SUPPLEMENTAL INSTRUCTION

PROJ.: Meridian Community
Building Rebuild
PROJ. No.: 1841
DATE: July 3, 2019
S.I. No. S.I. – A004

Revised Casement Window Size – Windows W38, W38R, W39 & W39R

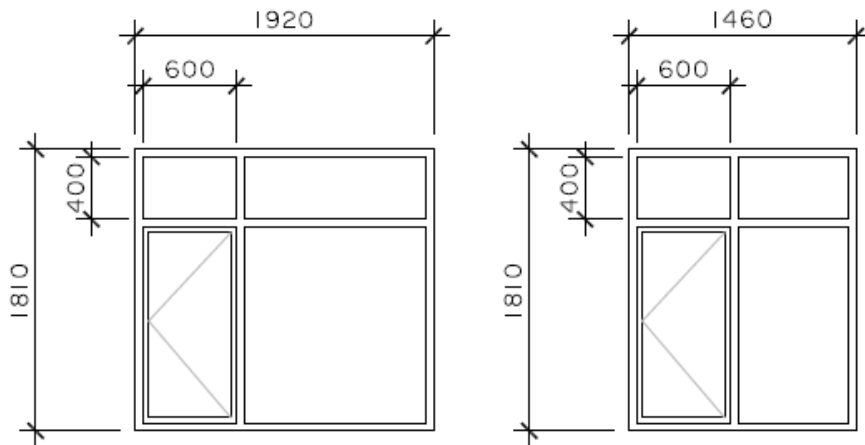
- .1 Increase the width of the casement operators on windows W38, W38R, W39 & W39R to +/- 610mm to allow for the installation of limiting hardware on the W38 and W38R windows on the west elevation of the links – see sketch below.

Shop drawing coordination – to meet minimum size requirement for installation of limiting hardware on windows of alternate supplier.
